Serial: RNP-RA/10-0028

H. B. ROBINSON STEAM ELECTRIC PLANT, UNIT NO. 2
DOCKET NO. 50-261/LICENSE NO. DPR-23

SUPPLEMENT TO REQUEST FOR
EMERGENCY TECHNICAL SPECIFICATIONS CHANGE
TO SECTION 3.4.17, CHEMICAL AND VOLUME CONTROL SYSTEM (CVCS)

Updated Final Safety Analysis
Report Figure 9.3.4-2

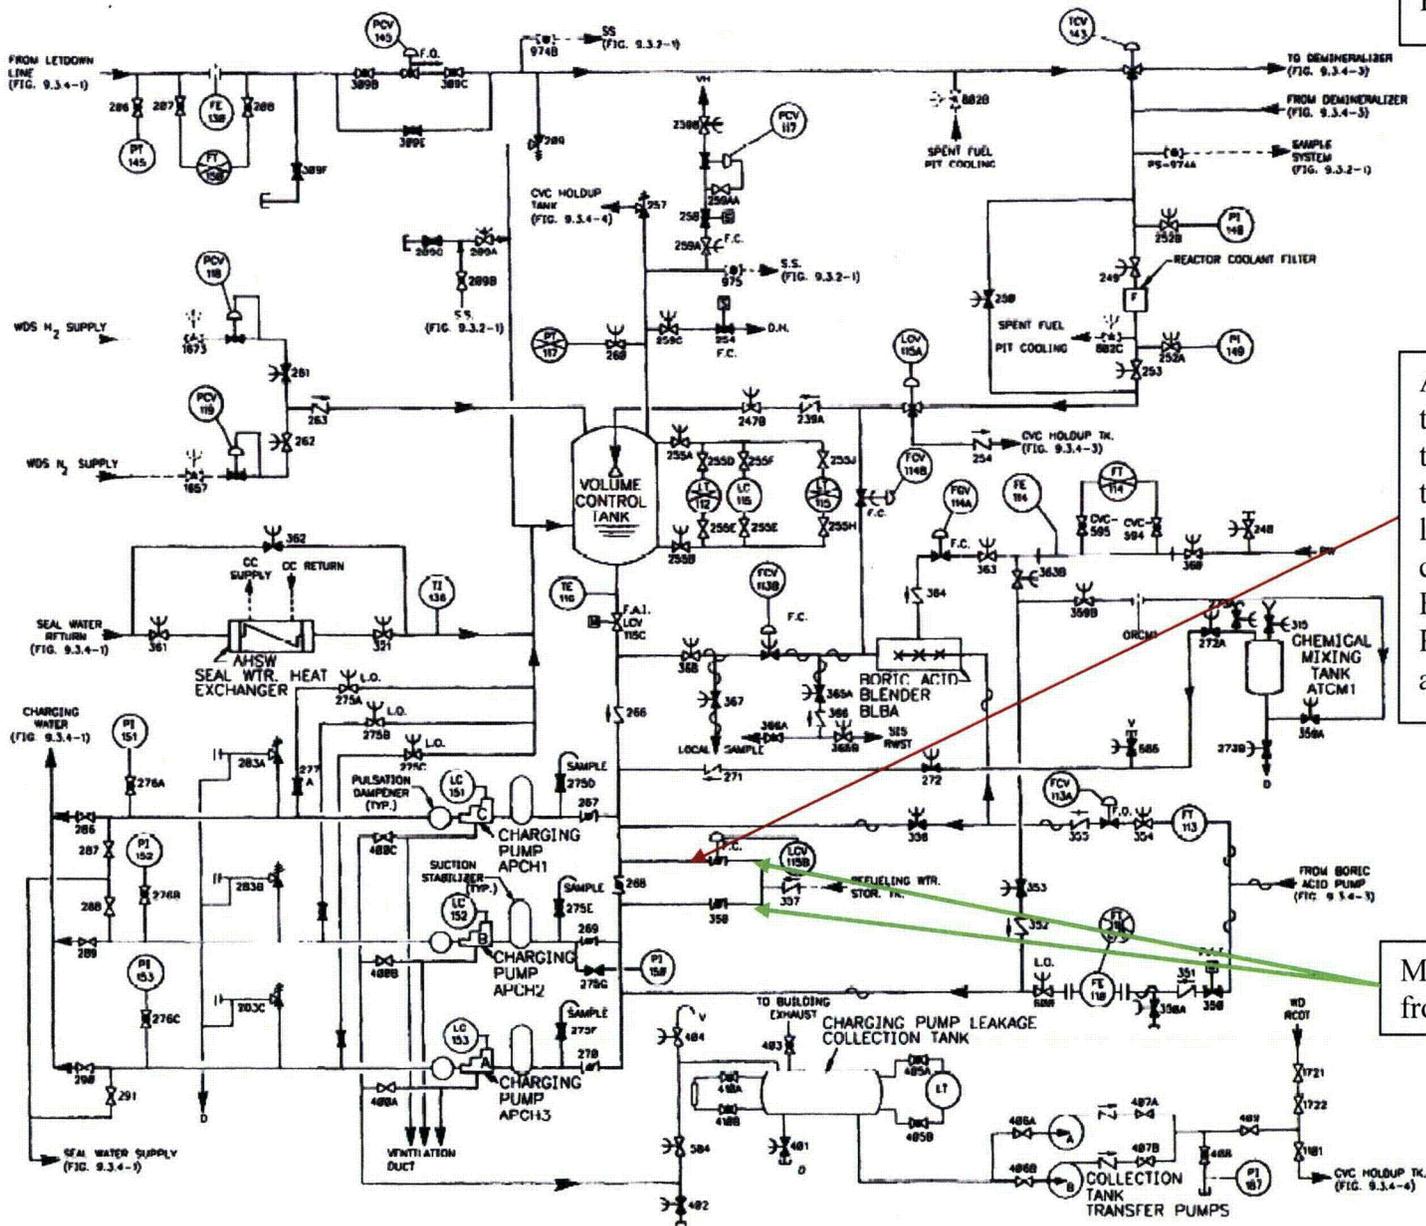
The need for the emergency approval of the proposed amendment results from the unexpected development of a leak in one of the makeup flow paths from the RWST. On March 16, 2010, a leak via a through-wall defect in a connection between the four-inch makeup flow piping to a three-quarter inch drain line was discovered after noting a decreasing trend in volume control tank (VCT) level. The leak rate was within allowable limits and a structural analysis of the measured defect determined that structural integrity was maintained. At approximately 08:10 hours on March 18, 2010, it was noted that the leak rate had increased and the flaw length had increased. The flaw length was approaching a value that would require declaring the piping inoperable, and hence would require entry into TS 3.4.17, Condition B. The visible surface flaw indication was initially measured at about 1.25 inches on March 16, 2010. The flaw size was estimated to be about 1.625 inches on March 18, 2010, with a calculated operability limit of 1.79 inches.

A temporary modification consisting of a mechanical brace was designed to limit propagation of the crack by reducing vibration of the drain line. The mechanical brace was installed at approximately 13:30 hours on March 18, 2010, to stop or slow the progression of the flaw. Given the high likelihood that the flaw could further degrade and exceed operability criteria, repair options for the leak are being planned. The repair options require the removal of one RWST pathway from service by use of one or more freeze seals in this line. In this condition with the line isolated, entry into TS 3.4.17, Condition B, is required. The repair options have a high likelihood of exceeding the current TS 3.4.17 Required Action B.1 completion time of 24 hours. Therefore, the current TS would likely result in the need for a plant shutdown during the repair of this piping. It is expected that the requested 72 hour completion time would allow sufficient time for repairs without the need for a plant shutdown.

Approximate location of the pipe flaw. Note that this figure does not show the drain connection at this location, which is consistent with the Updated Final Safety Analysis Report level of detail associated with this system.

Makeup water pathways from the RWST.
